Customer Support Bulletin

Number: CSB- 9802003

Subject: Inserting last I/O module into a Accelar 1200 chassis

Product: XLR1200

Accelar 1200 Chassis
Figure 1.

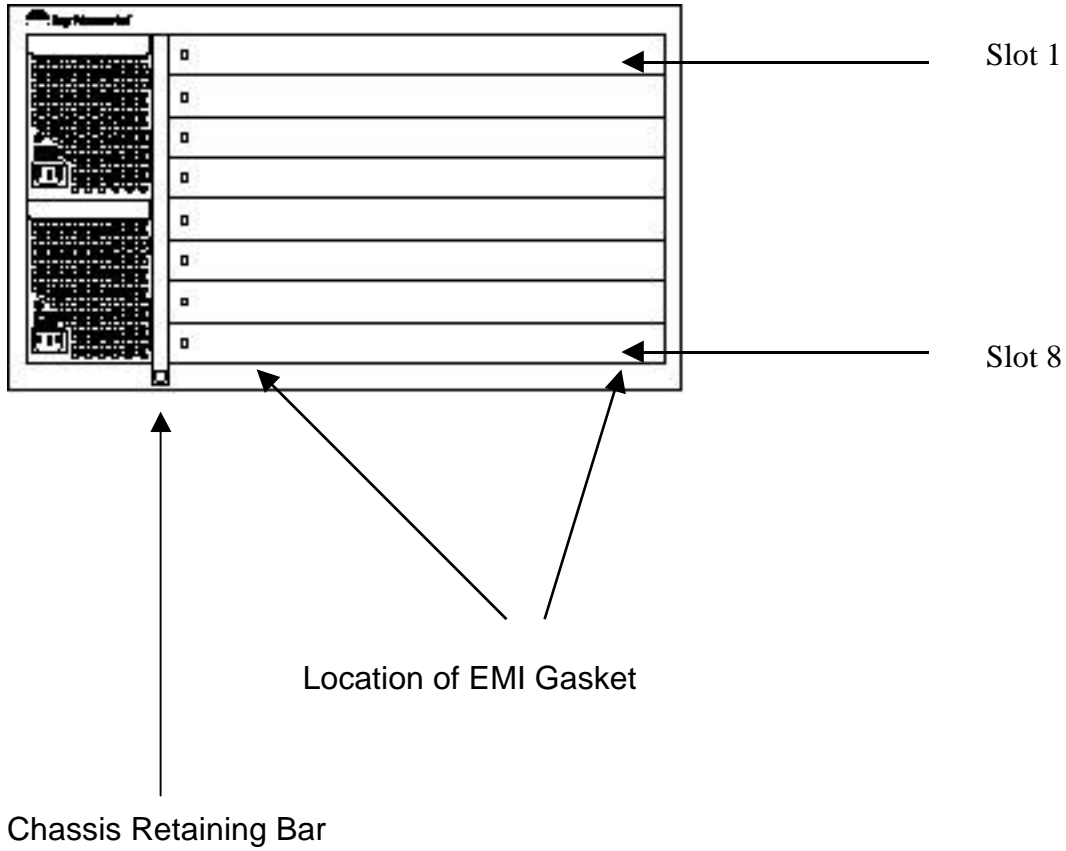
When installing all eight cards into the Accelar 1200 chassis (2 Silicon Switched Fabric cards and six I/O modules), there may not be enough vertical tolerance to insert the final I/O module. The beryllium EMI gasket on the chassis located under slot 8 may not allow for the proper vertical clearance. When installing the last card in a fully populated 1200 chassis and you incur resistance as the module is being inserted then you will need to remove the EMI gasket. If no resistance is incurred then there is no need to remove the EMI gasket.

To remove the EMI beryllium gasket follow these steps

1. See diagram figure 1 on page 2 of this CSB.
2. Turn power off and remove the AC power cord.
3. Remove chassis retaining bar, cover plates, I/O modules and SSF modules.
4. Using a pair of needle nose pliers and pull the EMI Gasket from the chassis located on the bottom of slot 8.
5. Reinstall the I/O modules and SSF modules starting with slot 1 and work your way down.
